Surge Tank Replacement

**Western Star
Service Bulletin**

Constellation
Heritage
> 4700 Models

Fig. 1, Plastic Frontwall-Mounted Surge Tank Installation

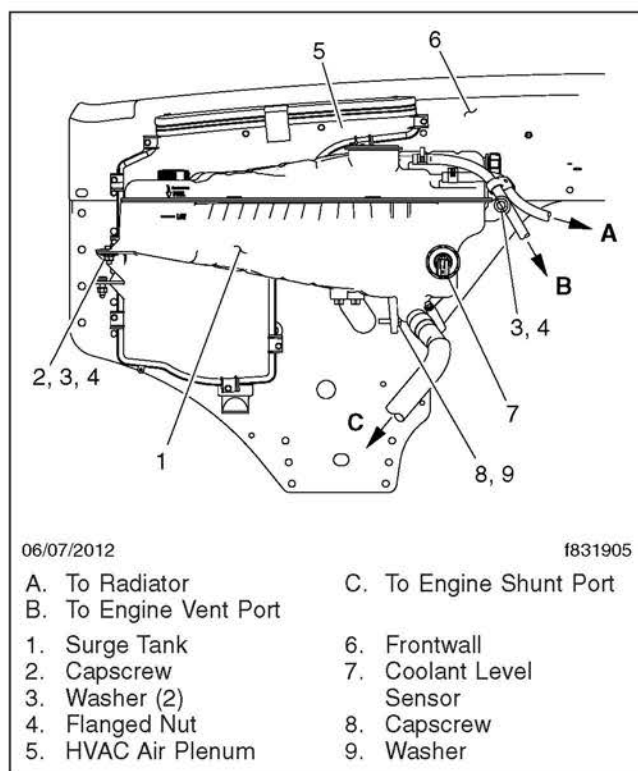
On some Western Star 4700 models, the plastic frontwall-mounted surge tank (A05-28531-001) may crack around the filler neck. If this occurs, replace the tank with the improved design part (A05-28531-002). See [Fig. 1](#) for a typical installation.

1. Park the vehicle on a level surface, shut down the engine, and apply the parking brakes. Chock the tires.
2. Remove the surge tank cap, and drain the coolant system enough to allow the surge tank to empty.
3. Mark the hoses attached to the surge tank for reference, then disconnect the hoses.
4. Disconnect the wiring harness from the low coolant sensor.
5. Remove the fasteners attaching the old surge tank to the air cleaner bracket, the HVAC plenum, and the frontwall.
6. Remove the old surge tank.
7. Remove the overflow hose from the old surge tank.
8. Install the overflow hose on the bottom of the new surge tank.
9. Position the new surge tank onto the air cleaner bracket, then install the fasteners. Tighten just enough to hold the surge tank in place.
10. Attach the new surge tank to the HVAC air plenum and the frontwall.

11. Tighten all the fasteners 18 lbf-ft (24 N-m).
12. As previously marked, connect the engine and radiator hoses to the surge tank.
13. Fill the coolant system through the surge tank.
14. Install the surge tank cap.
15. Connect the wiring harness to the low coolant sensor.
16. Start the engine and check for coolant leaks. Repair any leaks. Add coolant if needed.
